# UNITED STATES PATENT AND TRADEMARK OFFICE

APPLICATION NO.	FILING DATE	FIRST NAMED INVENTOR	ATTORNEY DOCKET NO.	CONFIRMATION NO.
10/652,110	08/29/2003	Constantin Bucur	O2MICRO 03.18	9841
32047	7590	06/09/2006	EXAMINER	
GROSSMAN, TUCKER, PERREAULT & PFLEGER, PLLC 55 SOUTH COMMERICAL STREET MANCHESTER, NH 03101			TIBBITS, PIA FLORENCE	
			ART UNIT	PAPER NUMBER
			2838

## Office Action Summary

**DETAILED ACTION**

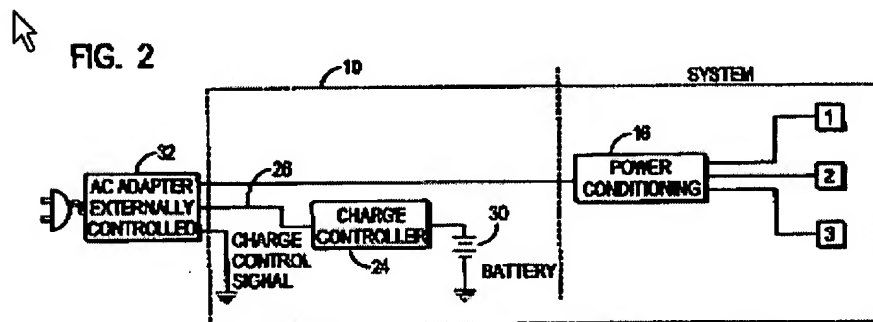
As to claim 9, the first switch is coupled between said fixed DC power source and said DC to DC converter: with regard to the particular location of the first switch, i.e., between said fixed DC power source and said DC to DC converter, absent any criticality, is only considered to be an obvious modification as it has been held by the courts that there would be no invention in shifting the location of

a structure of a device to another location if the operation of the device would not thereby be modified.

*In re Japikse*, 181 F.2d 1019, 86 USPQ 70 (CCPA 1950) MPEP 2144.04

FIG. 3

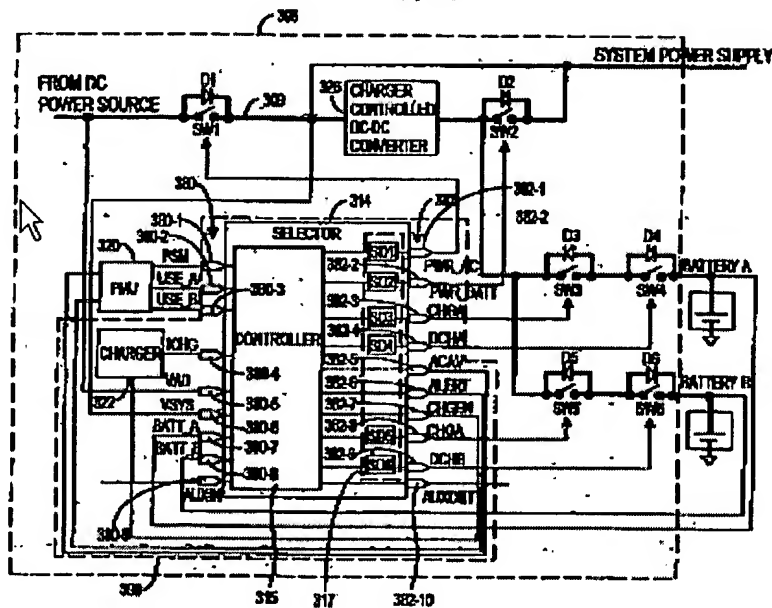
5. Applicant's arguments that the claimed limitations have antecedence in the parent cases have been fully considered but they are not persuasive.

b) Parent case 10364228 discloses a selector circuit for power management in multiple battery systems:
